Review of Signal Operations for Pedestrians in the City of Melbourne

Report on the Action Stream of Draft Walking Plan 2014-17

For: City of Melbourne, Transport Planning Unit

19 April 2014

Figure 17: Phasing arrangement for scramble phase

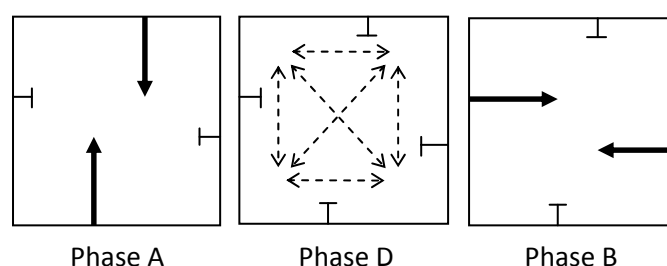
Exclusive pedestrian phases are sometimes called a Barnes Dance or a scramble crossing. During this phase in the traffic signal cycle, pedestrians are allowed to walk diagonally across the intersection as well as parallel to the roads. An example is at the intersection of Flinders St and Elizabeth St.

- result in slight increases in overall average pedestrian delay
- markedly increase overall average vehicle delay
- increase average tram delays by at least double.

Once a scramble phase is introduced, it is very difficult to remove it. Pedestrians get used to certain operations and take time to adjust to different phasing. It is also inadvisable to operate a scramble phase at some times of the day then revert to normal two-phase operation at night. Safety is dependent on operating conditions meeting road users' expectations.

It is recommended that scramble phases should not be considered as part of the Walking Plan.
